Rezoning Application:

MM 22-0884

Hillsborough
County Florida

Development Services Department

2.3 Proposed Site Plan (partial provided below for size and orientation purposes. See Section 8.0 for full site plan)

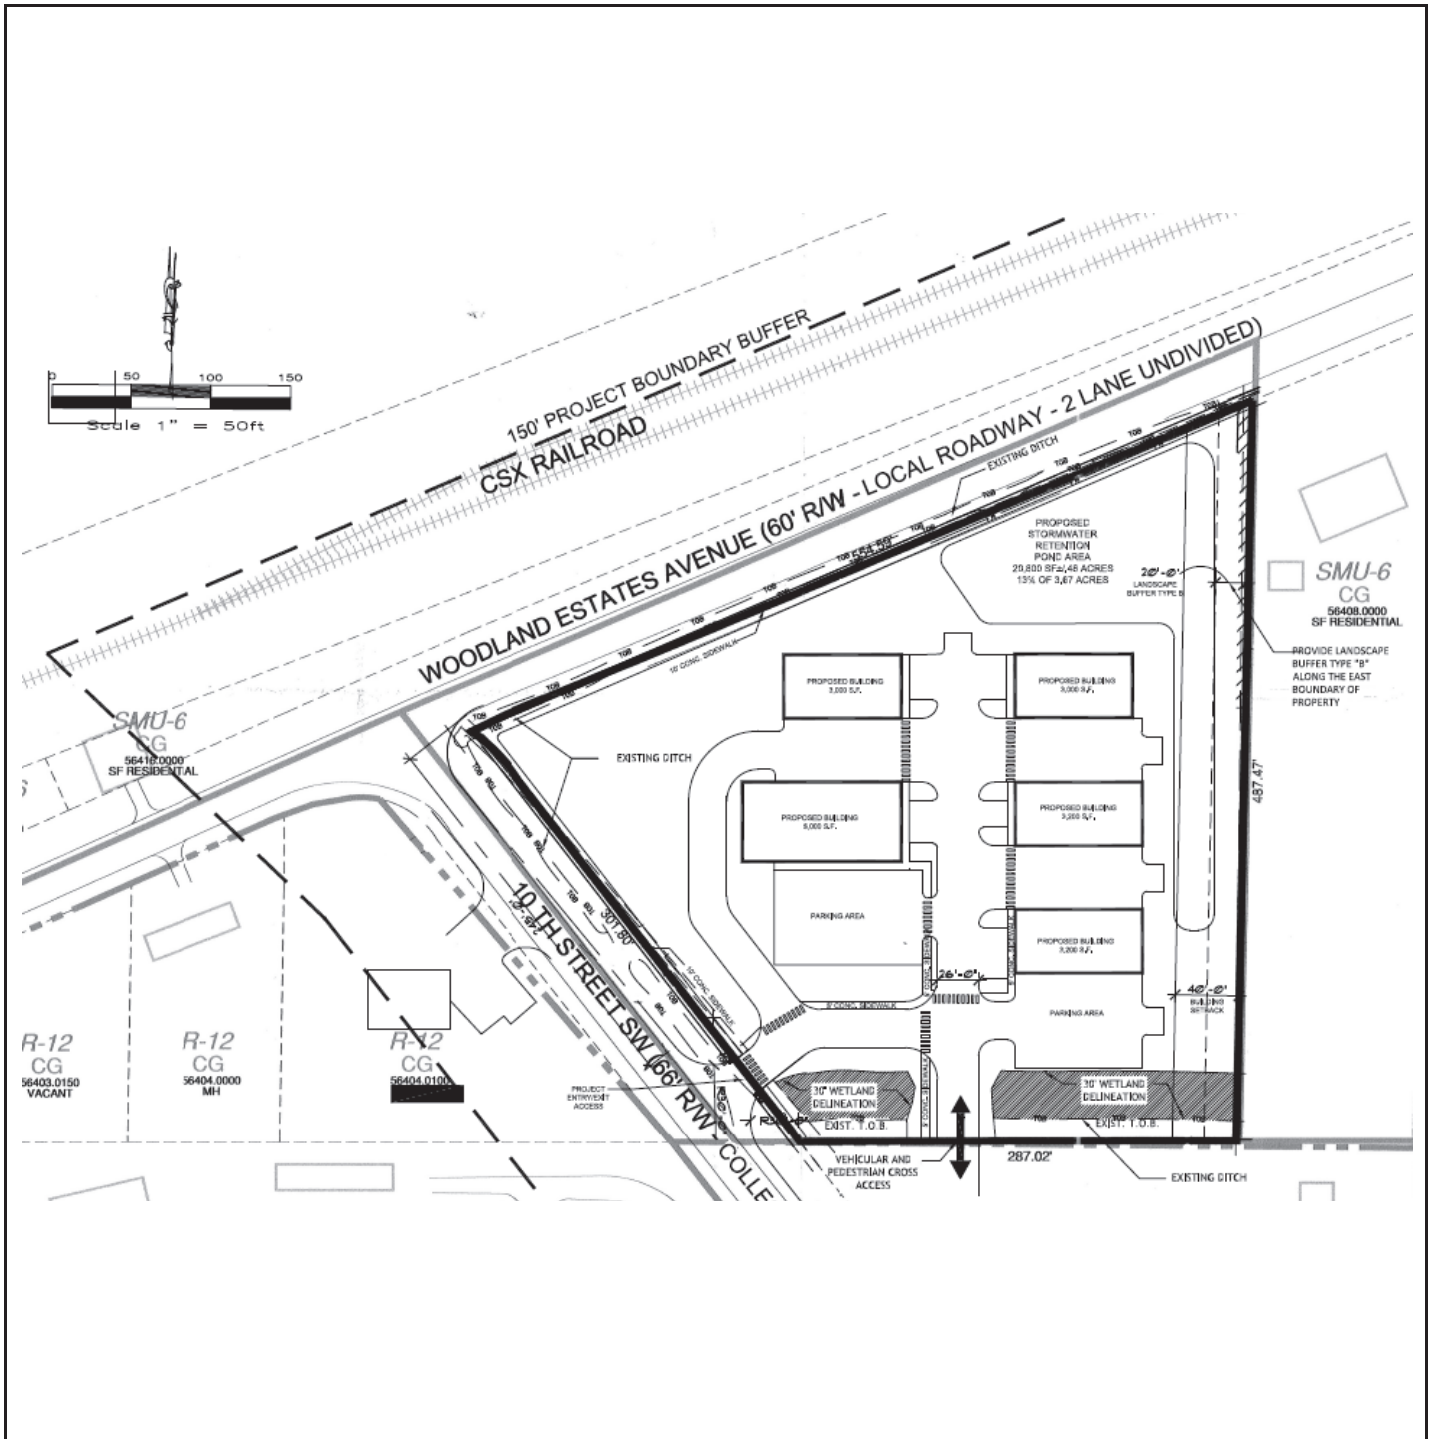
- Revise Proposed Use "Contractor's Office and General Office, General Office does not include Medical Office Uses" to "Professional Services, Professional Offices and Contractors Offices".
- Revise the "40-ft. building setback" shown as measured from the eastern property boundary to be shown from the additional 2 feet of setback for every foot of height over 20 feet setback.

WBW CONTRACTORS OFFICE PARK Connection Spacing Diagram

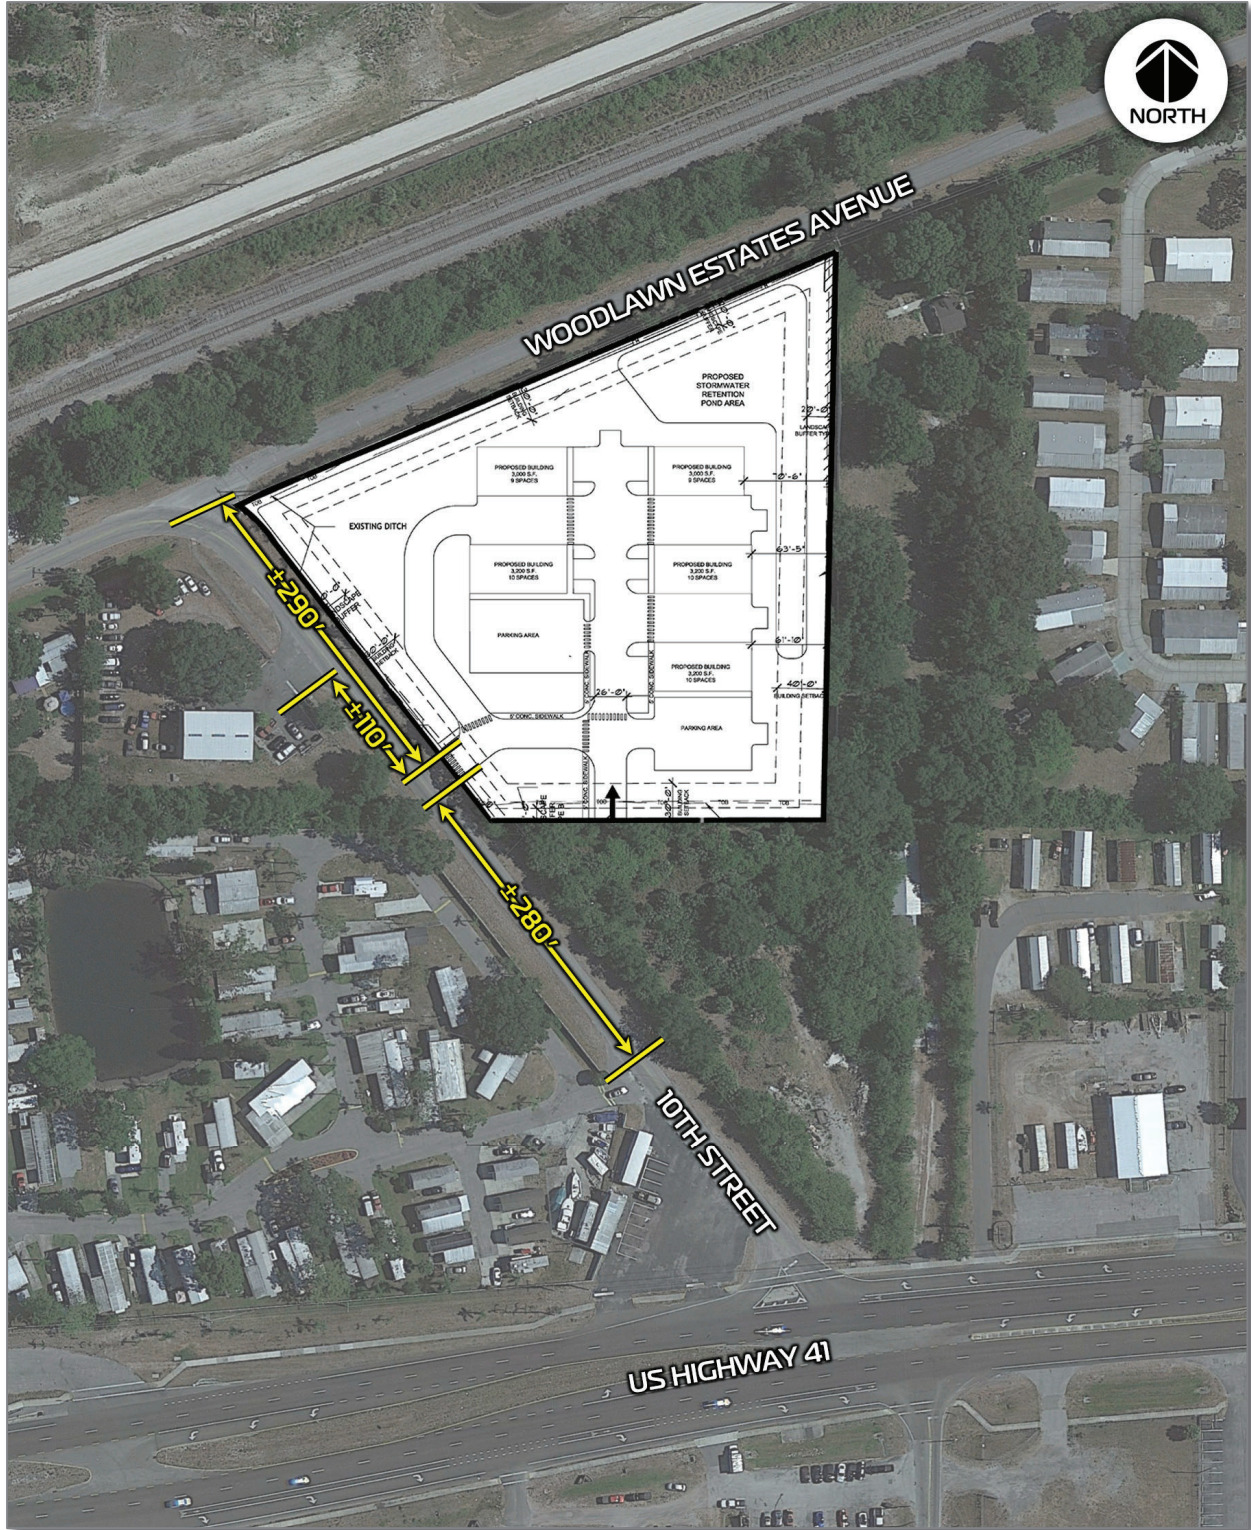
- If PD 22-0884 is approved, the County Engineer will approve an Administrative Variance (dated January 23, 2023) which was found approvable by the County Engineer (on January 25, 2023) for minimum access connection spacing. This administrative variance will allow for the location of the project’s access connection on 10th Street to be located within +/-110 feet of an existing driveway on the west side of the roadway. as shown on the PD site plan.

BASED ON THE INFORMATION PROVIDED BY THE APPLICANT, THIS REQUEST IS HEREBY APPROVED.
